# Wendy's®

## AT CORAL CREEK US- 441 & JOHNSON ROAD COCONUT CREEK , FLORIDA

PLAN NUMBER	USB-NRE-55
LOCATION	COCONUT CREEK, FLORIDA
SITE ADDRESS	US 441 & JOHNSON ROAD
JURISDICTION	COCONUT CREEK, FLORIDA
OWNER	WENDY'S INTERNATIONAL, INC.
PROJECT No.	CKE # 1405
PLAN DATE	FEBRUARY 13, 2017

SHEET NAME  
**SITE PLAN**  
 SHEET NUMBER

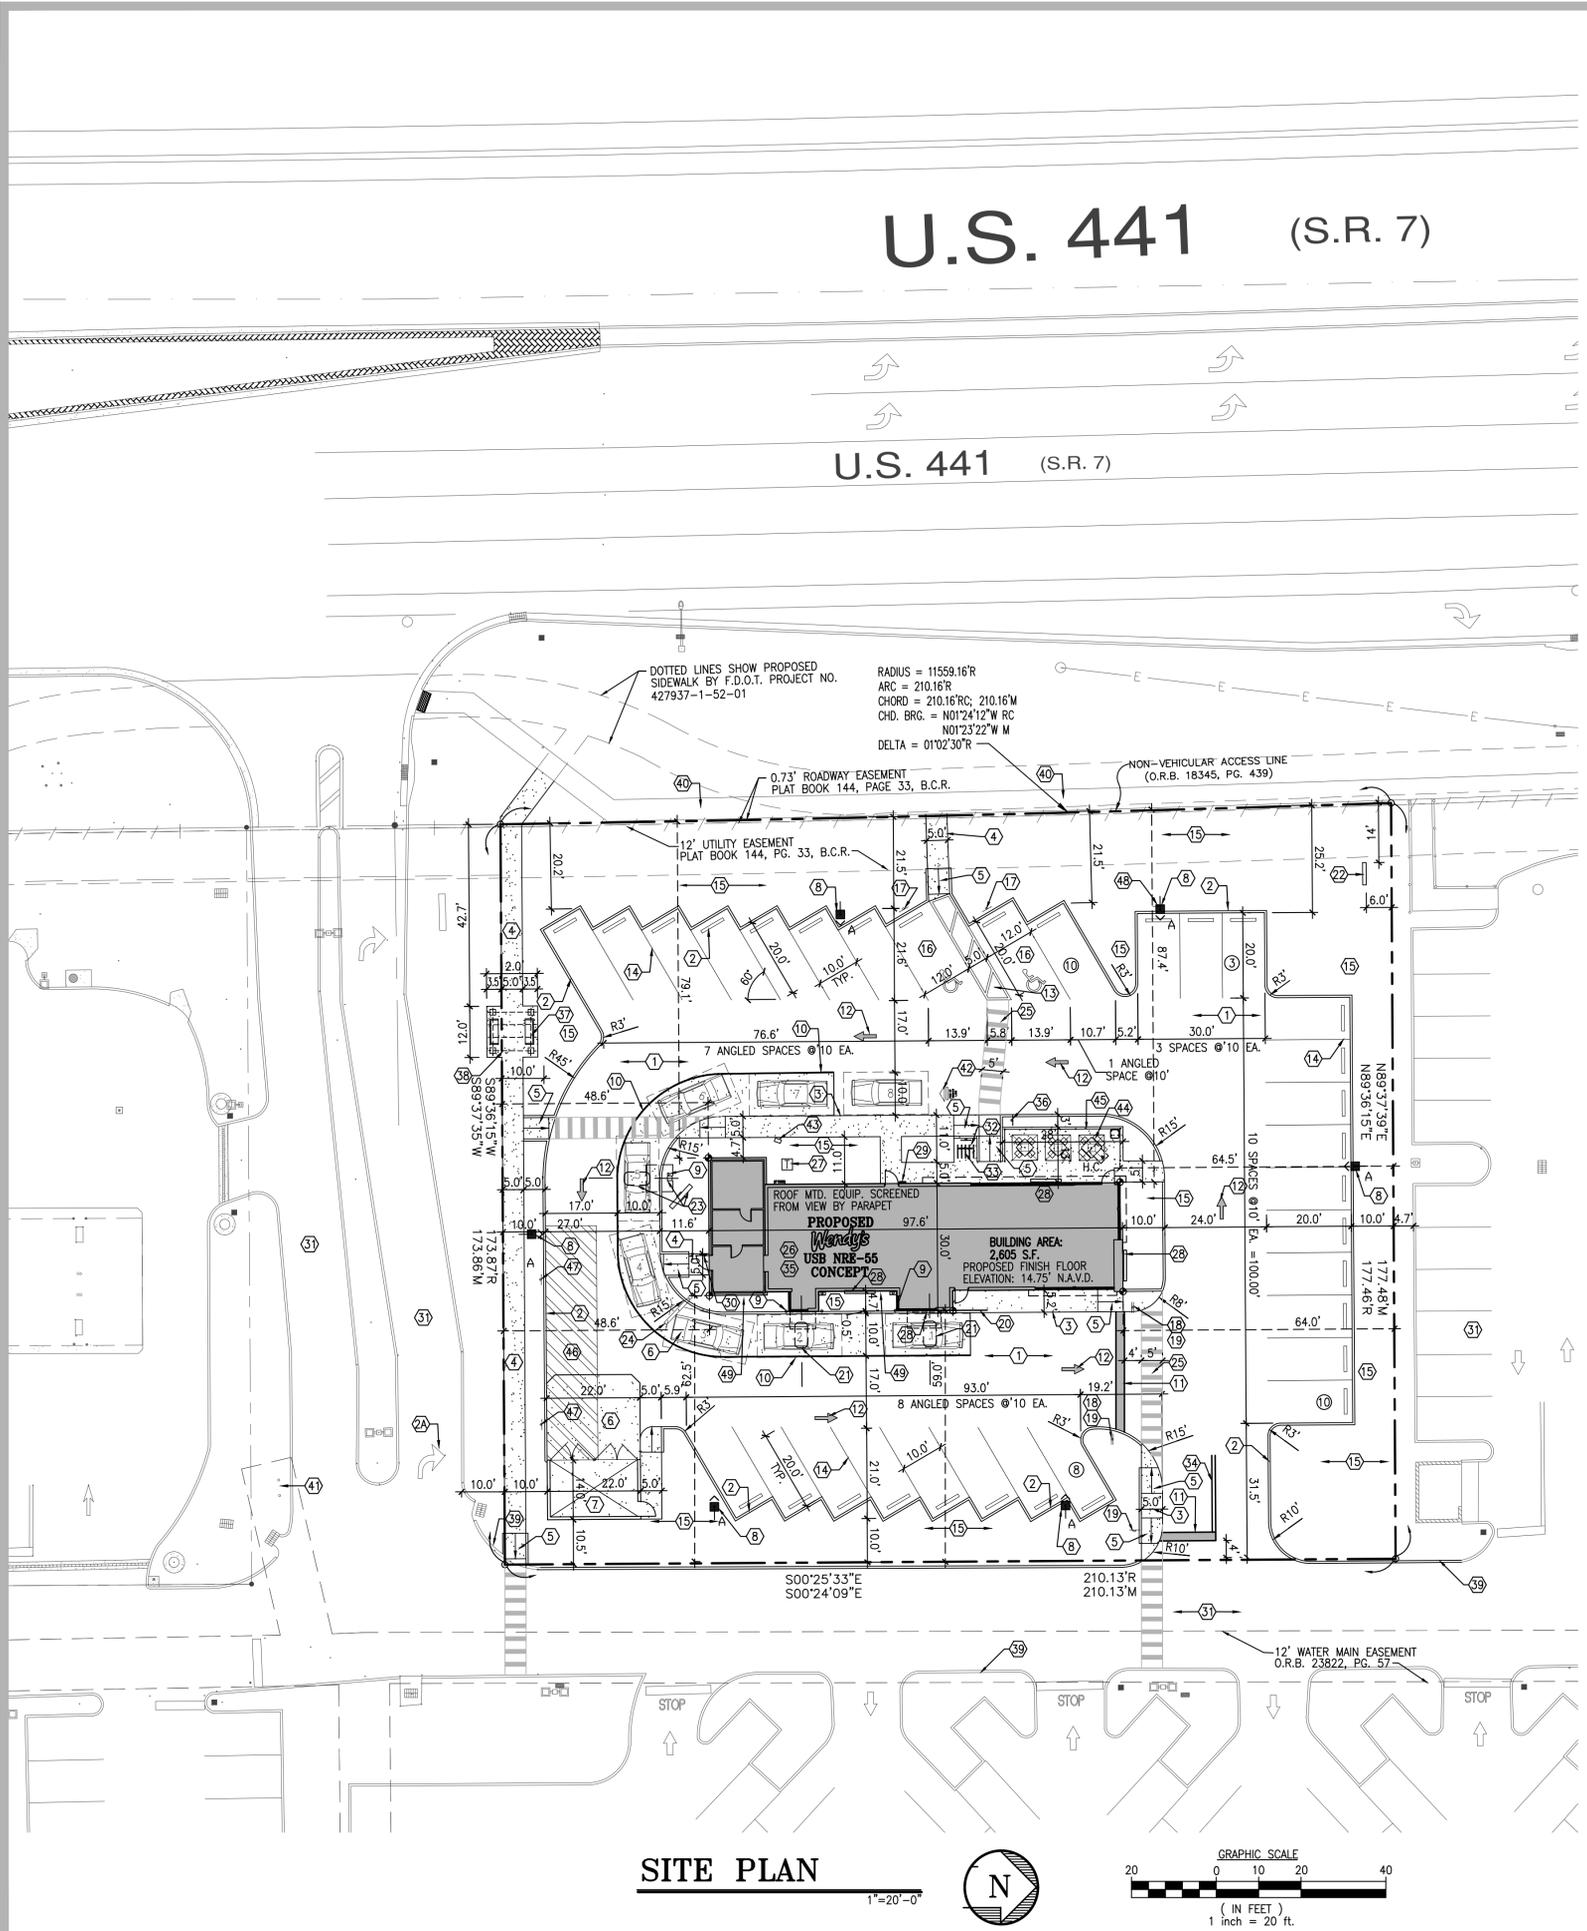
15. Provide total pervious and impervious area before and after proposed construction on sheet SP-2.

20. Clarify item #31 on sheet SP-2.

28. Item #22, monument sign – Identify location of monument sign on Sheet SP-2.

**Response: Please refer to table on Sheet SP-2 and C-1.**

**Response: Please see sheet SP-2 where item #31 has been corrected to item #22.**

**Response: Please see sheet SP-2, where the monument sign has been correctly identified as #22.**
